44471A-01**S E R V I C E N O T E**Supersedes:
NONE**44470A** 10 channel multiplexer module for 3499A/B. Includes a screw terminal block**44471A** 10-channel General Purpose Relay for 3499A/B. Includes a screw terminal block**44473A** 4x4 Matrix Module for 3499A/B. Includes a screw terminal block**44474A** 16-bit Digital I/O Module for 3499A/B. Includes a screw terminal block**Serial Numbers:**

Defective connectors shipped with 44470A, 44471A, 44473A, 44474A

Figure 3: Defective Connector with all pins on one side

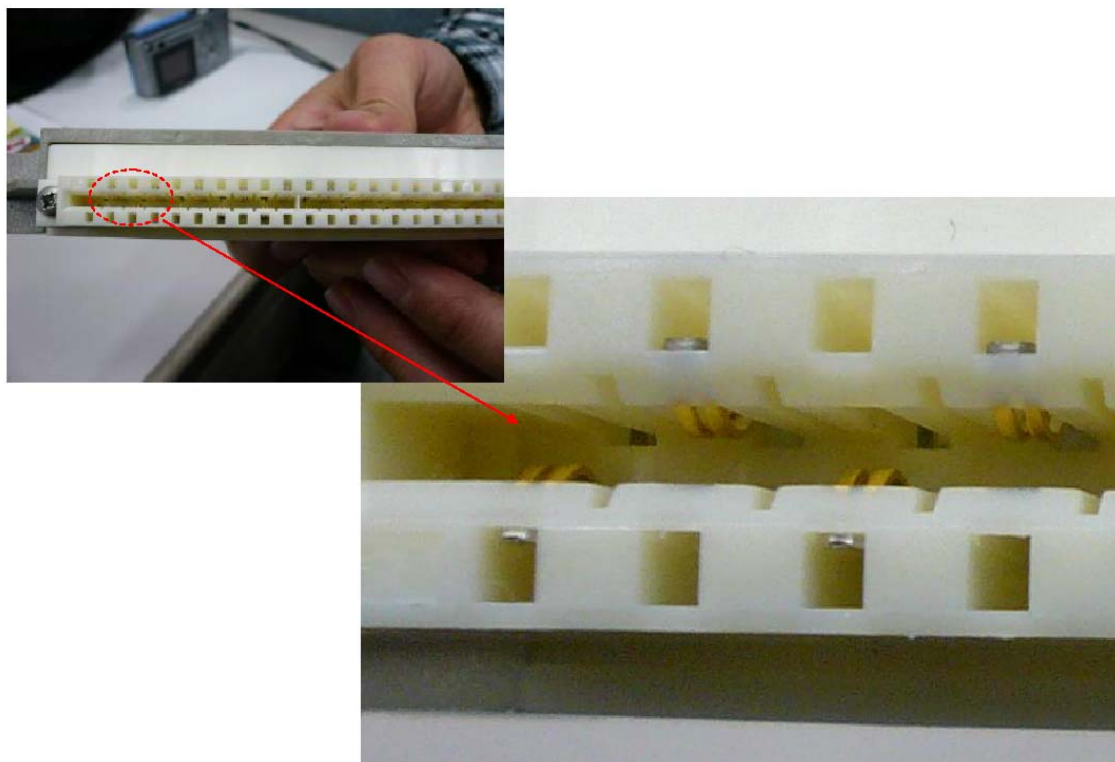
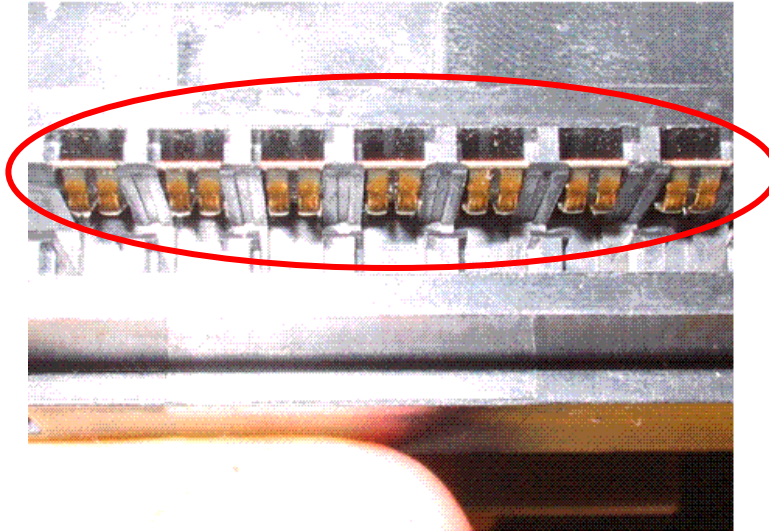
The 44470A, 44471A, 44473A, and 44474A products consist of a main relay plug in module and a removable terminal block (see Figure 1). These are plug in modules for the card cage mainframes 3488A, 3499A, 3499B, and 3499C. The main relay card contains the serial number. The removable terminal module does not contain a serial number. A visual inspection of the connector in the removable terminal block is necessary to determine if a defective connector is present. All white colored connectors are good and have pins that alternate top to bottom (see Figure 2). A black colored connector is bad if it contains all pins on one side of the connector (see Figure 3). A black colored connector is good if it contain pins that alternate top to bottom (not pictured).

The procedure to correct the defective connectors is very simple. One must replace the defective connector with a good connector (see connector part numbers list on page 2). The customer may perform this procedure or have an Agilent-qualified person perform this procedure.

Figure 4: Removing defective connector from terminal block

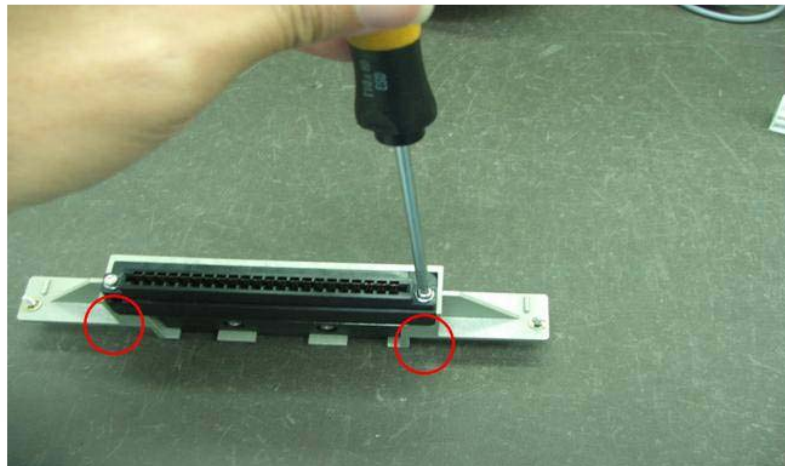
Connector Replacement Procedure: After identifying a defective connector, the connector in the terminal block is repaired by removing the two screws that hold the connector to its case. Note the orientation of the connector. This will release the connector from the terminal block and then a good one can replace it. No soldering is necessary. See Figure 4.

1. Use a T10 torx driver to unscrew the 2 screws of the connector.

Use the same torx driver to screw on the good connector, using the same orientation at the connector you just removed (see Figure 5).
